# Pro-L25000UNL

## Firmware v2.14 Release notes

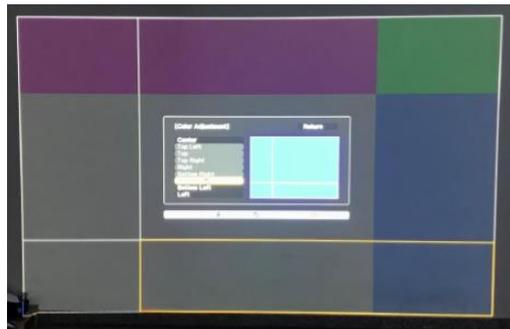
1. I2C error might happen when turning off projector power right after "pilot mode\*2" is released  
\*2. "Pilot mode" automatically reduces brightness of projection image after an elapse of a certain period when "Sleep Mode" is set to "On"
